Freetown Central Park

Town of Freetown ADA Transition Plan

June 2023

Institute for Human Centered Design

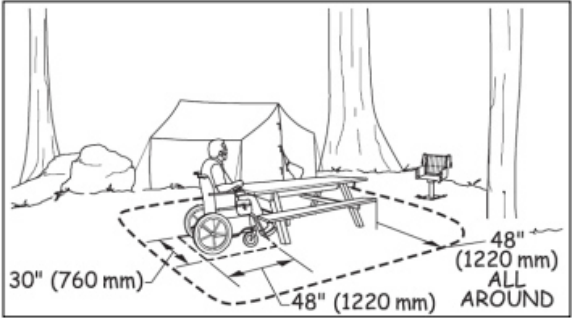
- Recommend providing visual contrasting strips on all stair treads.
- Recommend providing a stable, firm and slip-resistant surface that is 48" wide min. on all sides of the accessible picnic table in each distinct area where picnic tables are provided. See the following illustration:
